CITY OF PORTLAND

BUILDING PERMIT

Located At 295 FOREST AVE

has permission to Place a 10' x 26' prefabricated storage building at the rear of the building for "Clink" recycling provided that the person or persons, firm or corporation accepting this permit shall comply with all of the provisions of the Statues of Maine and of the Ordinances of the City of Portland regulating the construction, maintenance and use of the buildings and structures, and of the application on file in the department.

Hannaford Back Cove
Clynk Site Plan 7/20/12

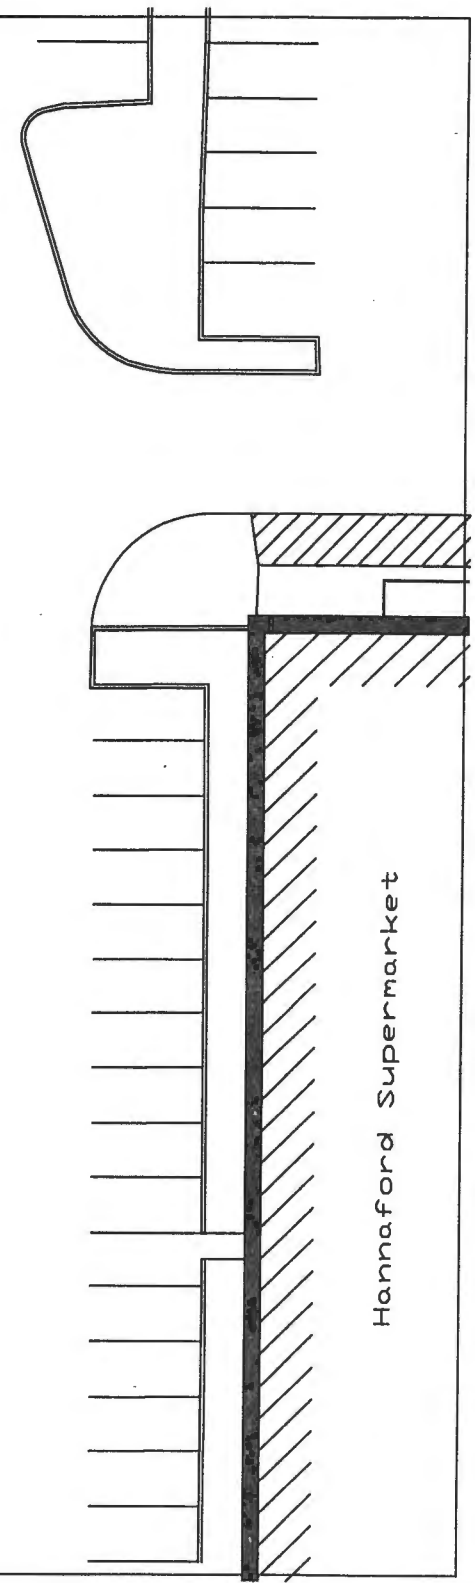
I have reviewed the applicant's information and I find their response to be acceptable. My only comment is that the area next to the proposed building should be available so vehicles exiting parking spaces can easily turn around when exiting the small parking lot (the space where the building is being located was designed for a vehicle turn around). I do not want vehicles backing up into the main circulation aisle.

Hi Barbara – I have reviewed the applicant's information and I find their response to be acceptable. My only comment is that the area next to the proposed building should be available so vehicles exiting parking spaces can easily turn around when exiting the small parking lot (the space where the building is being located was designed for a vehicle turn around). I do not want vehicles backing up into the main circulation aisle.

1. The area next to the proposed building should be available so vehicles exiting parking spaces can easily turn around when exiting the small parking lot.
2. The existing landscaping shall be retained as a buffer.
3. The proposed setback of 8 feet meets the zoning setback requirement for accessory structures, according to Ann Machado, Zoning Specialist.
4. The applicant shall obtain all required City Permits, including building permits from the Inspection Division (874-8703) and any other permits required from the Department of Public Services (874-8801) prior to the start of any construction.

FOUNDATION PLAN

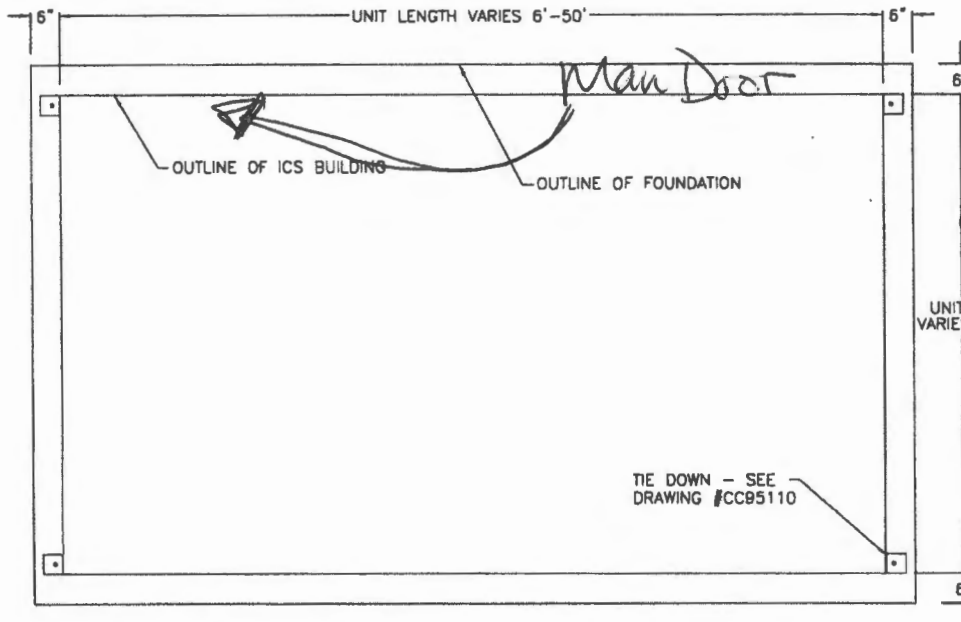
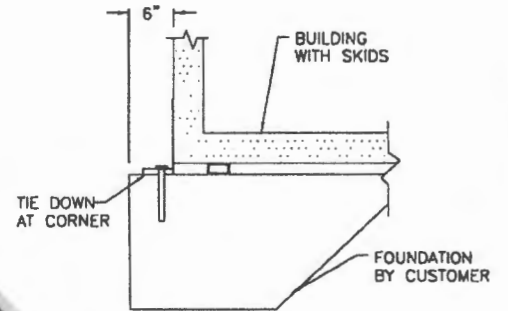
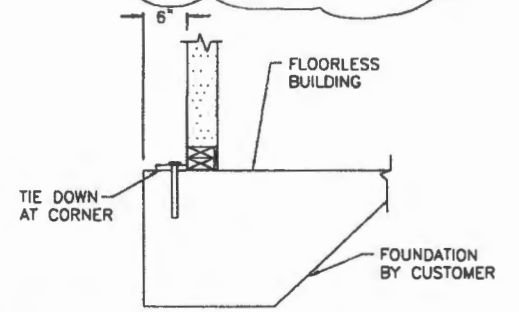
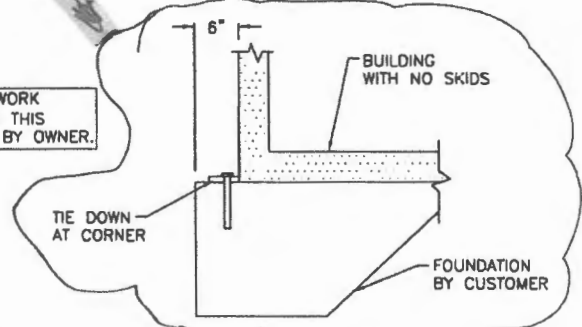
UNIT SHIPS WITH BOTTOM SKIDS, BUT WE INTEND TO REMOVE THEM WHEN BLDG IS PLACED IN FINAL LOCATION.
